Access Compliance Report

Public Rights-of-Way

(Curb Ramps)

Intersection ID: 53212	Main Street: IDLEWILD_RD	Cross Street: N/A	Location: NE
ADA ID: 61771145E4F3	Ramp Type: Directional1	Initial Pass/Fail: Pass	Overall Compliance: No
		Severity Score: 0.25

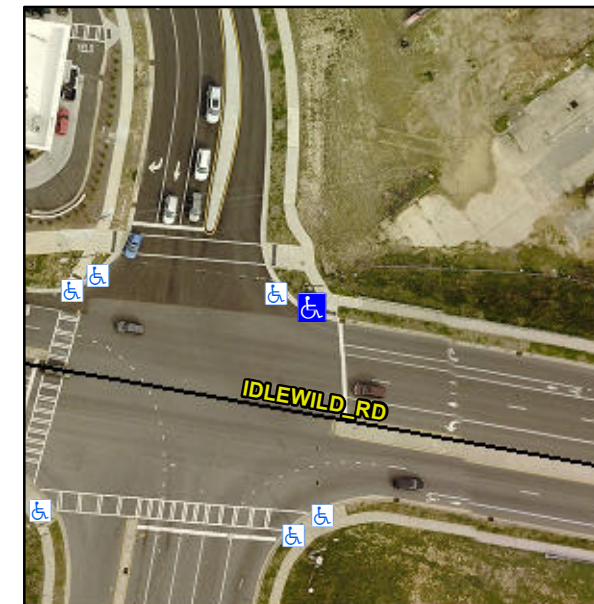
R304.5.3

Compliance	Description	Data	Compliance	Description	Data
N/A	Ramp Length (in)	61.0	Yes	Grade Break?	Yes
Yes	Ramp Width (in)	71.0	Yes	Grade Break Slope (%)	0.4
Yes	Ramp Slope (%)	4.1	Yes	Grade Break XSlope (%)	0.5
Yes	Ramp XSlope (%)	4.0			
Yes	Flare Type LT	N/A	Yes	Flare Type RT	N/A
N/A	Flare Slope LT (%)	N/A	N/A	Flare Slope RT (%)	N/A
N/A	Flare Traversable LT?	No	N/A	Flare Traversable RT?	No
Yes	Landing Length (in)	70.0	Yes	DWS Provided?	Yes
Yes	Landing Width (in)	71.0	Yes	DWS Contrast?	Yes
Yes	Landing Slope (%)	1.3	Yes	DWS Length (in)	24.0
Yes	Landing X Slope (%)	1.9	Yes	DWS Full Width?	Yes
N/A	Landing Curb? (Y/N)	No	Yes	DWS Offset LT (in)	1.0
N/A	Shared Landing?	No	Yes	DWS Offset RT (in)	7.0
Yes	Gutter Ponding?	No	Yes	Gutter Slope (%)	1.2
Yes	Gutter Lip Ht (in)	0.0	No	Gutter X Slope (%)	4.7
N/A	Painted X Walk1?	No		Road Slope (%)	0.3
	X Walk 1 Direction	To S		Road X Slope (%)	4.4
	X Walk 1 Width (in)	N/A		Clear Space?	Yes

Remove & Replace Gutter.
